STAFF RECOMMENDATION
822 Fatherland Street
December 16, 2020

Application: New Construction--Addition
District: Edgefield Historic Preservation Zoning Overlay
Council District: 06
Base Zoning: R8
Map and Parcel Number: 08216026000
Applicant: Michael Ward, Allard Ward Architects
Project Lead: Jenny Warren, jenny.warren@nashville.gov

Addition and Renovations to the:
Dyke-LaDuke Residence
822 Fatherland Street
Nashville, Tennessee 37206

Figure 4 & 5: Aerial photograph of current enclosed rear porch. 1982 photograph of rear porch

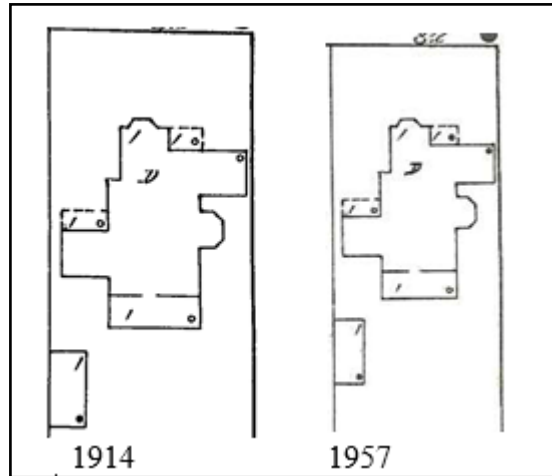
In order to construct the rear addition, a portion of the existing rear of the house will be removed. This piece stretches across most of the rear elevation and has a separate lower roof form. The approximate footprint of this portion appears on Sanborn maps dating back to 1898, however a photograph from 1982 (Figure 5) shows that this was a screened porch as late as that date. It has since been enclosed. Staff finds that this altered rear porch no longer contributes to the historic or architectural significance of the district and that its removal is appropriate. Staff therefore finds that the proposed demolition meets Section V.B.2 for appropriate demolition and does not meet section V.B.1 for inappropriate demolition.

Figure 8: Interior side elevation

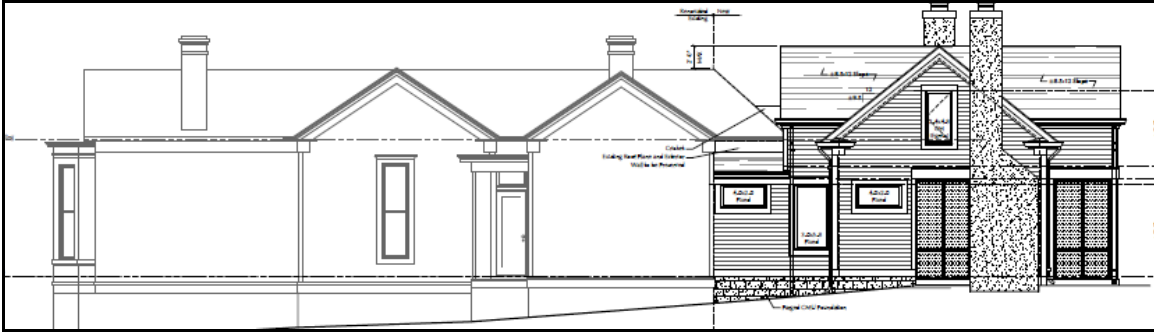
meeting the historic proportions of openings. There are two small horizontal windows on the interior side elevation. (Figure 8) Staff finds these could be appropriate as they are far back behind the projecting side gable and are accent windows rather than the primary window type. There are no large expanses of wall space without a window or door opening.

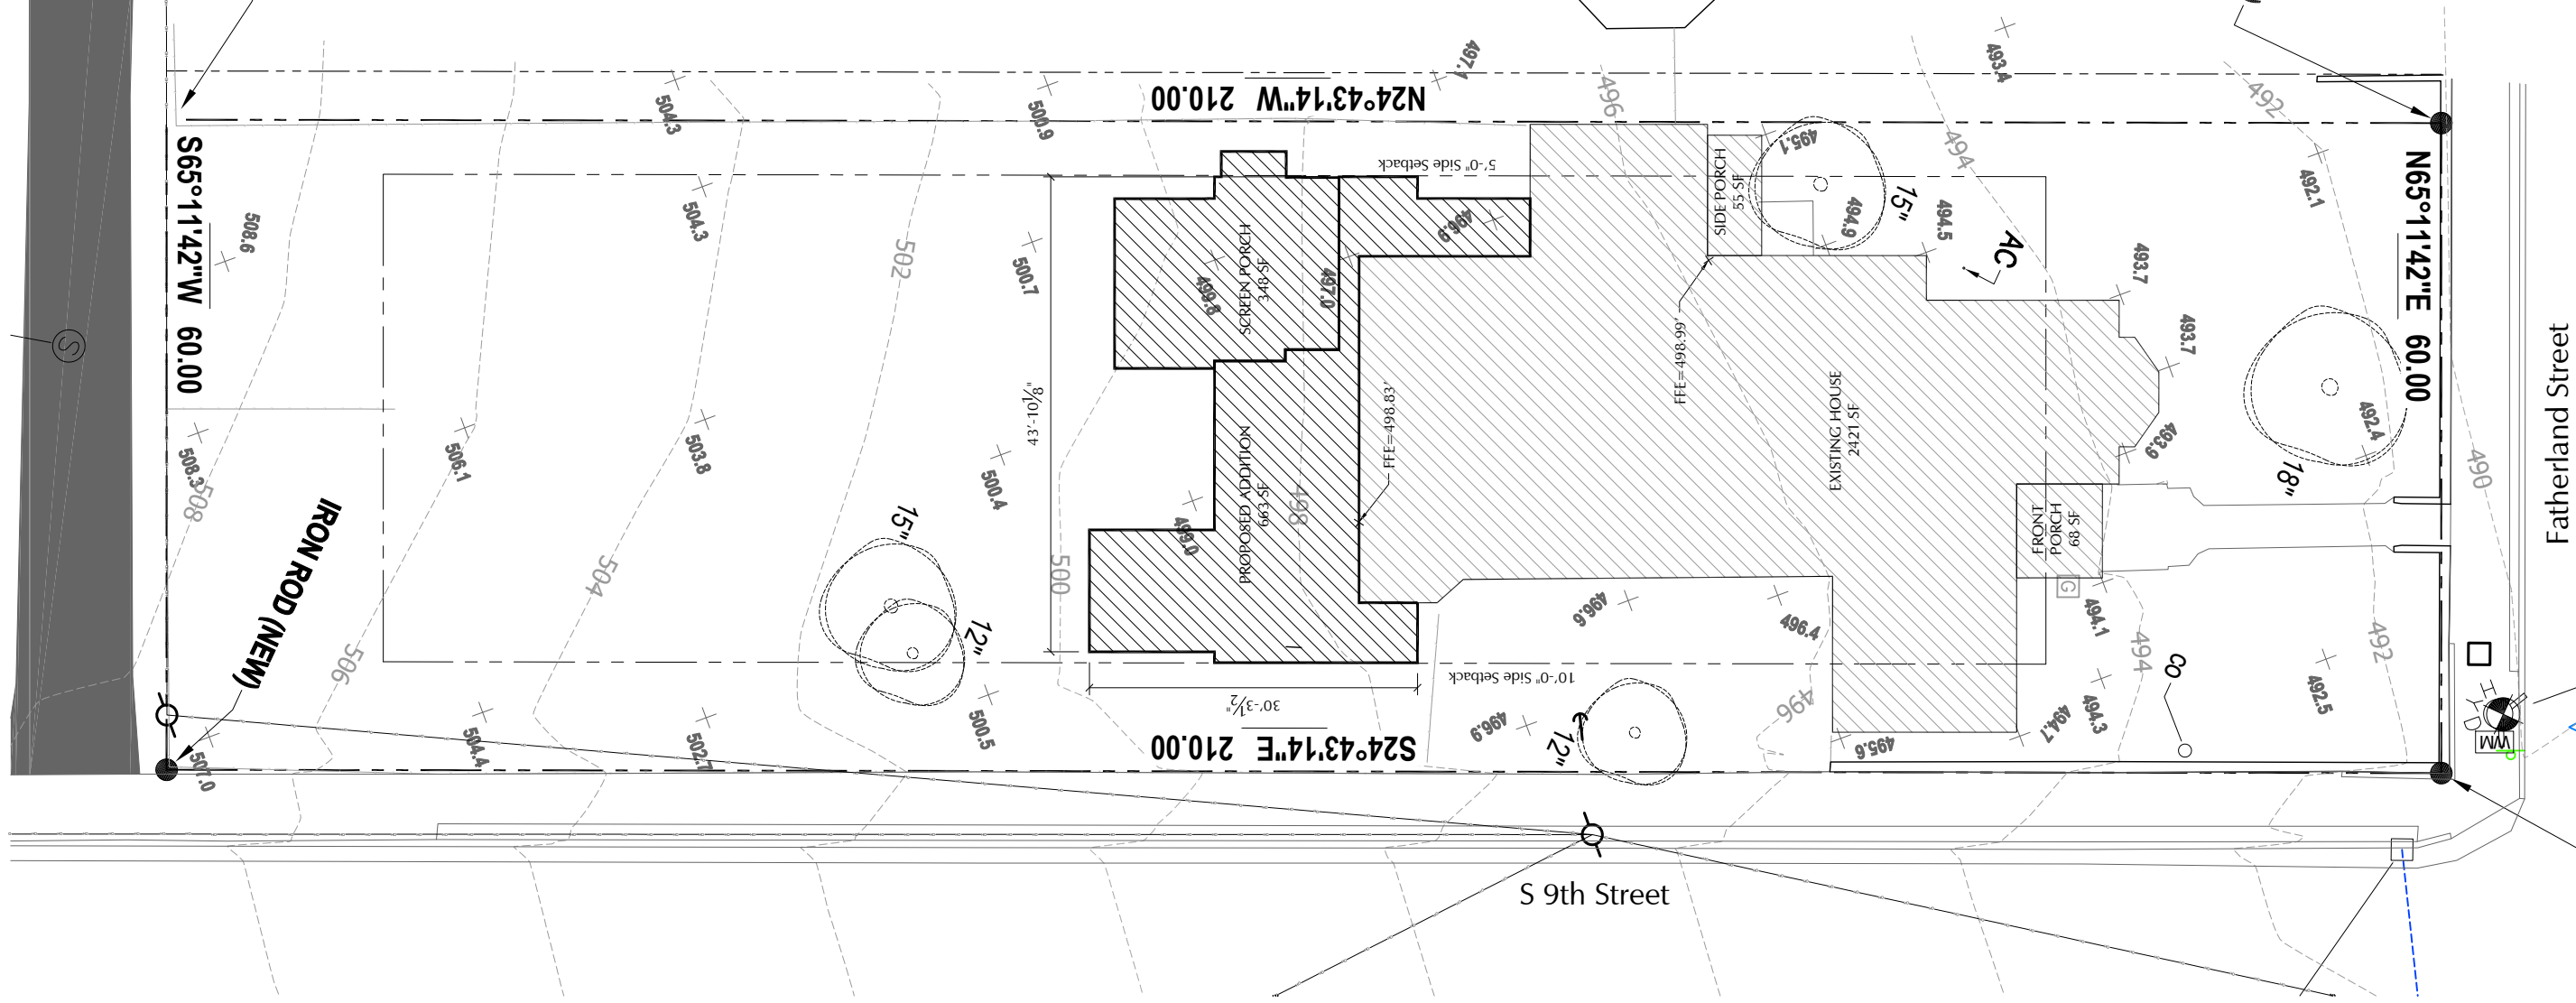
The proposed addition will be approximately twenty feet (20') from finished floor at its highest point. The historic house is approximately eighteen feet (18') from finished floor. The guidelines allow for additions that step taller if they are set forty feet (40') back from the front of the house. The proposed addition steps taller about sixty-four feet (64') from the front of the house. The addition will step in as typically required of additions and will have a separate roof form. The eave heights have been designed to match the existing eave heights, which helps to mitigate the increased ridge height, particularly along the side street.

Figure 6: 9th Street elevation. Rear addition is sixty-four feet (64') back with a separate roof form

Proportion and Rhythm of Openings: No changes to the historic window and door openings on the existing house were indicated on the plans. The existing non-historic windows along the 9th Street elevation (Figure 7) are being replaced. (Figure 6) The windows on the proposed addition are all generally twice as tall as they are wide, thereby
